Title:                   Advisory Committee on Reactor Safeguards  
                              (ACRS) NuScale Subcommittee,  
                              Open Session

Date:                    Wednesday, November 20, 2019

22 The intended purpose of this presentation  
23 is to provide a general overview of the NuScale  
24 accident source term methodology. Areas of discussion  
25 are principally based on methodology positions for

Enclosure: "ACRS Subcommittee Presentation: NuScale Topical Report – Accident Source Term Methodology," PM-1119-67927, Revision 0

# NuScale AST Methodology

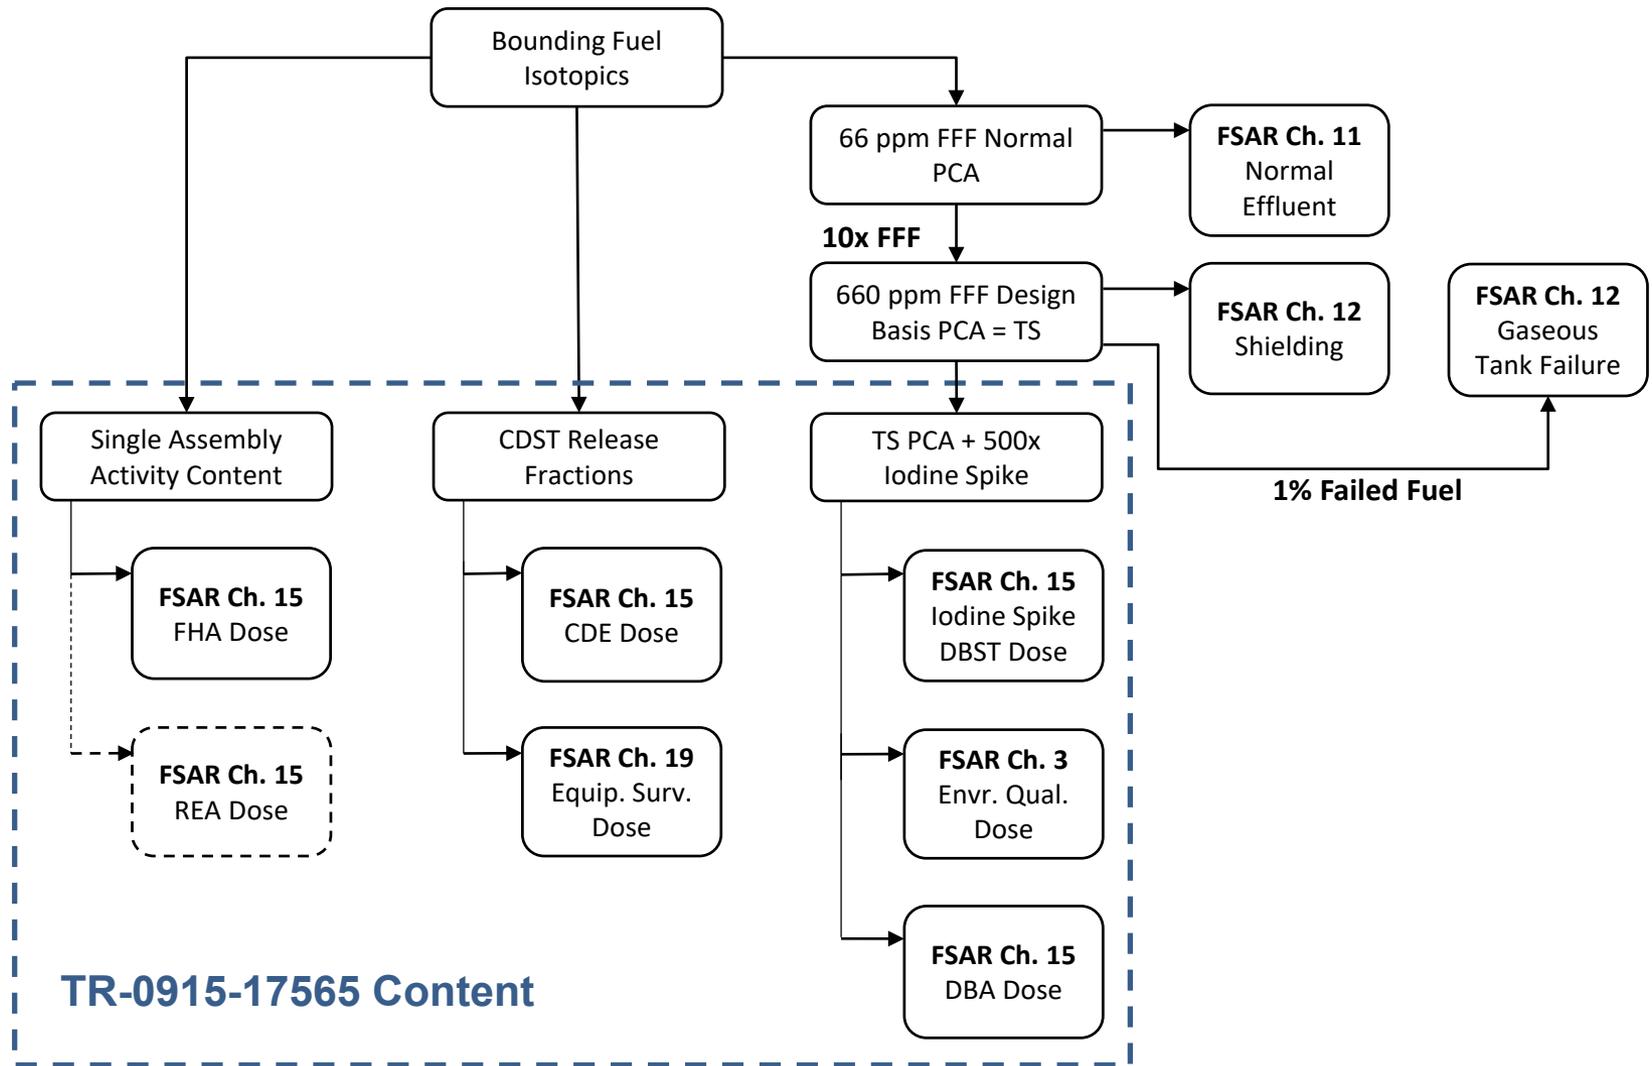
21 MR. GUINN: If there is nothing more we'll  
22 head to the next slide. This figure provides an  
23 overview of dose evaluation products that are provided  
24 by the accident source term topical report.

3 Some source term applications, which are  
4 extraneous to the topical report, are included in the  
5 upper right portion of the figure. Now, this is  
6 because this is intended to be a recurring figure  
7 throughout today's presentations and will be reused  
8 later to outline wider application of source terms in  
9 NuScale licensing submittal areas.

10 CO-CHAIR PETTI: So, just a question. I  
11 want to ask something outside the blue dash.

9 MR. GUINN: -- this figure is kind of  
10 unfortunate.

# RADTRAD Model Nodalization

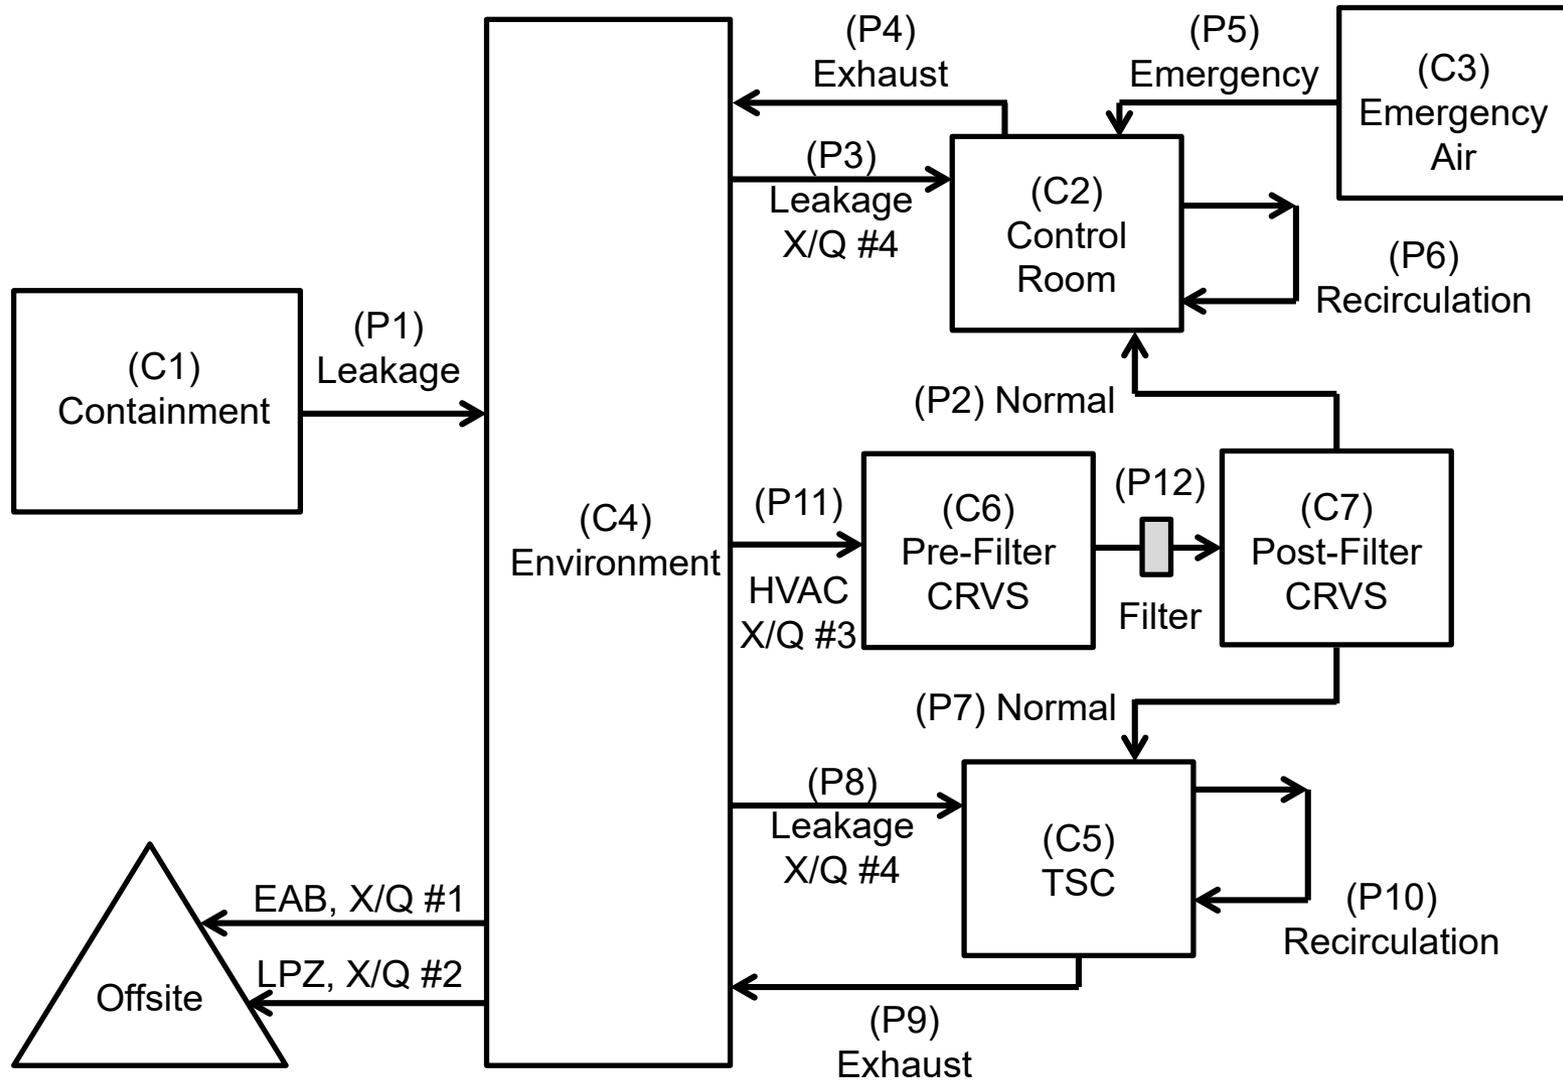
20 MR. GUINN: Next. Here is the RADTRAD  
21 model nodalization figure that's shown. This is the  
22 example of our core damage event model.

1 room inhabitability systems in this figure.

# Source Term Overview

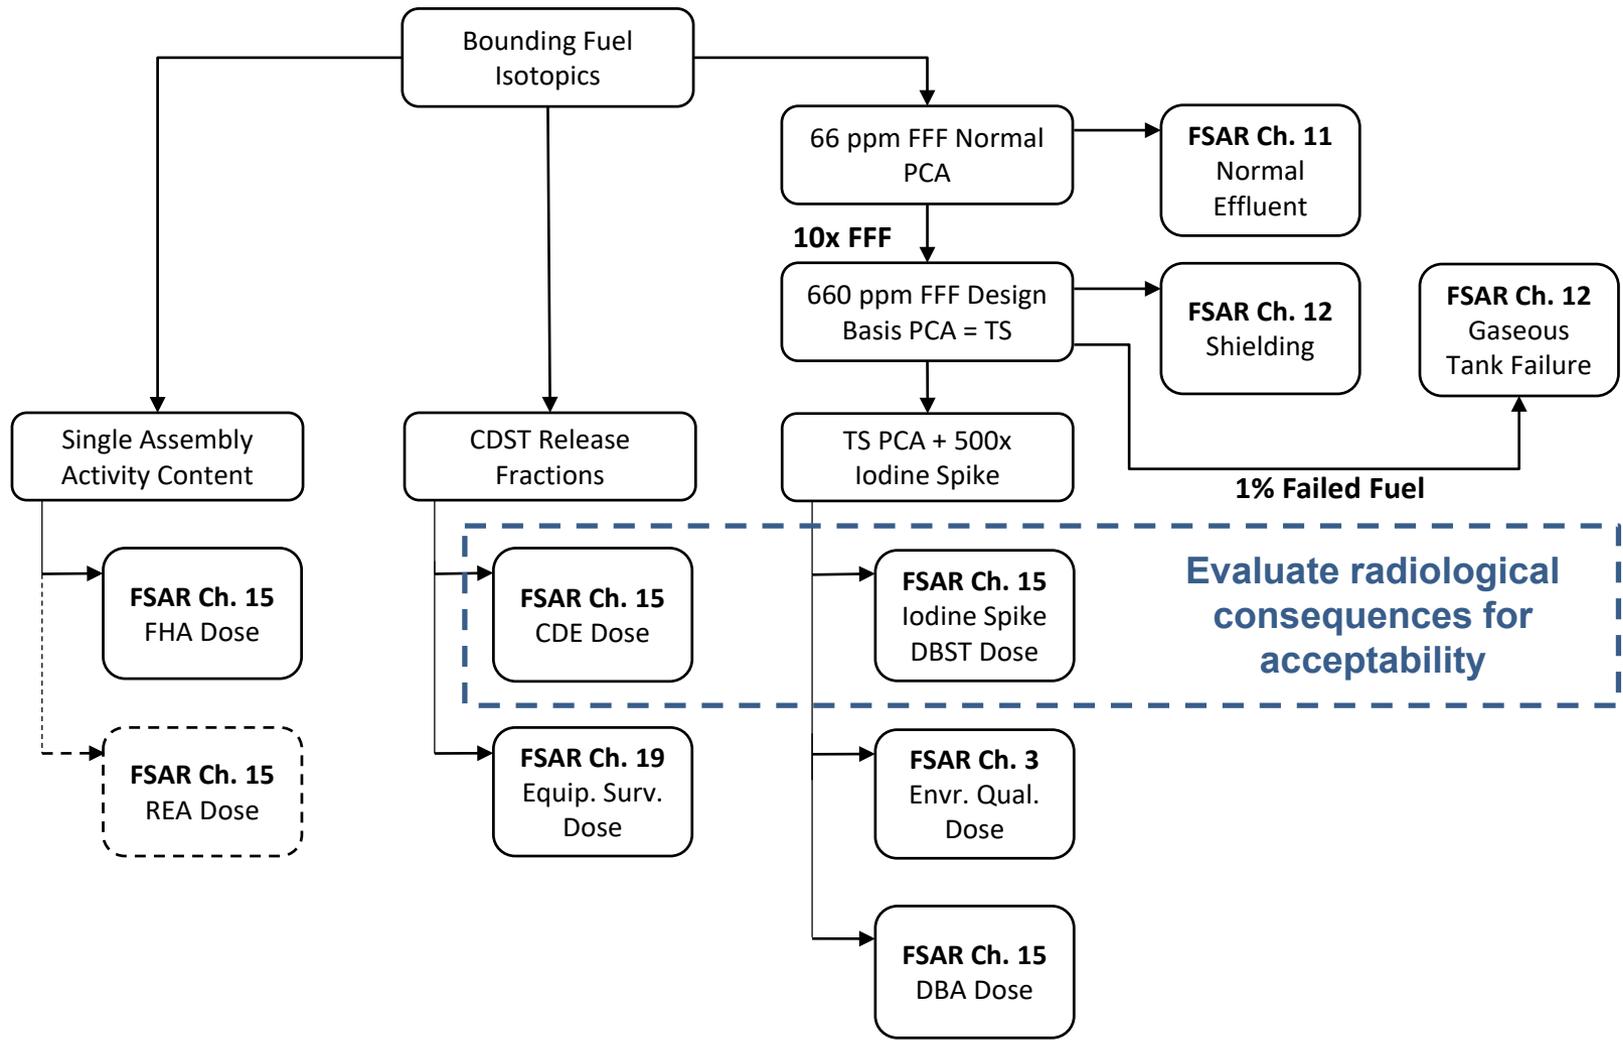
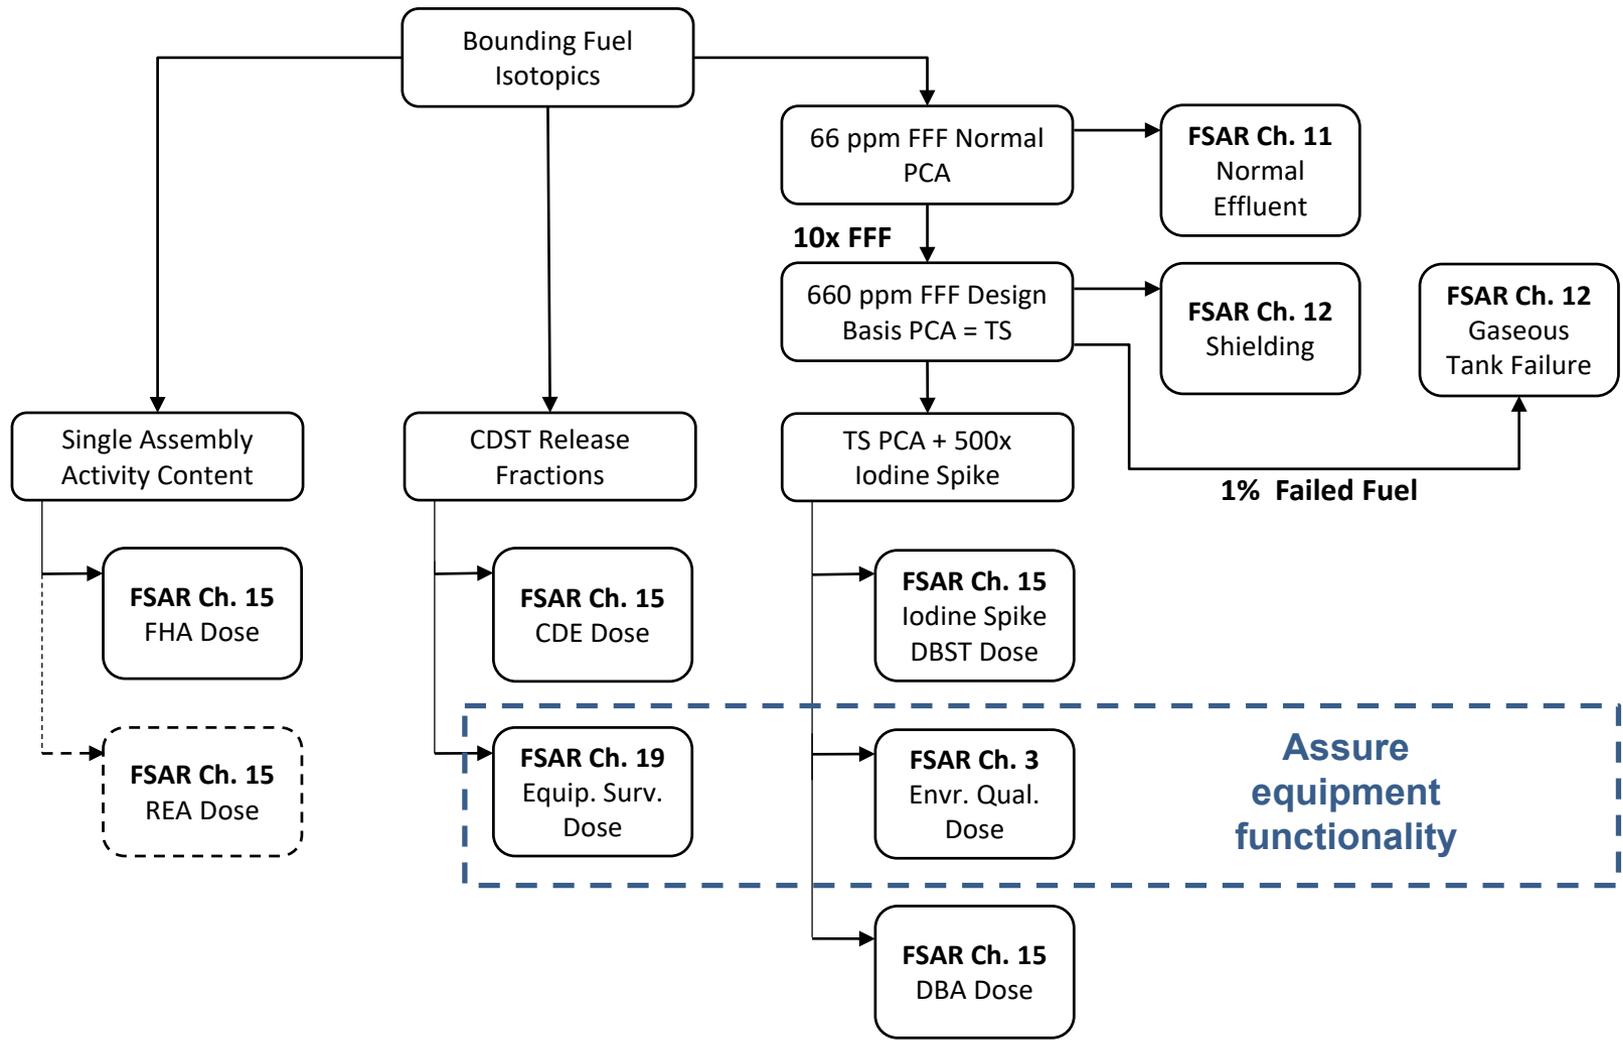
9 DR. SCHULTZ: Mark, excuse me. I'm sorry  
10 to have to back you up, but on the previous slide on  
11 Chapter 12, I thought the figure showed Chapter 12  
12 evaluation connected to the 1 percent fuel failure  
13 assumption.

21 DR. SCHULTZ: Well, the figure shows it's  
22 running to Chapter 12. That's where I got confused.  
23 Okay. That clears my question. Thank you.
